Project Addresses: 306 N Brooks Street

Application Type: Demolition Permit, Zoning Map Amendment, Conditional Uses, and Certified Survey Map Referral

Legistar File ID # [83527](#), [83907](#), [83529](#), and [83531](#)

Prepared By: Chris Wells, Planning Division
Report includes comments from other City agencies, as noted

Image 1: Building Heights Surrounding the Subject Site. (Source: Vierbicher Associates)

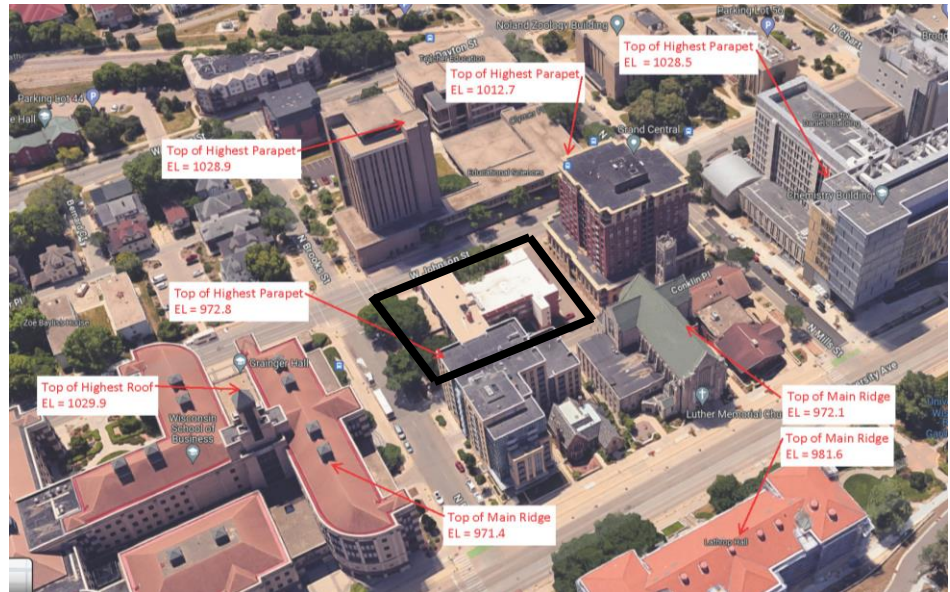
As a measure of building scale, staff have used building height as a proxy. The proposed building height is roughly 161 feet, which equates to roughly 1,032 feet above sea level. (The Capital View Preservation height limit is 187.2 feet above City datum or 1,032.8 ft above sea level). For comparison’s sake, the applicant team prepared a building height survey of the surrounding parcels (see Image 1 below).

This means that there are three buildings located in the surrounding block (four if you count the Grainger Hall spire) that rise up to at least the 1,012-foot mark (or within roughly 20 feet of the proposed building), two of which rise up to less than five feet of the proposed building. Furthermore, the proposed building’s mass and stepbacks closely resembles that of the adjacent Grand Central apartment building to the west which also has a roughly five-story base before stepping back on all sides.
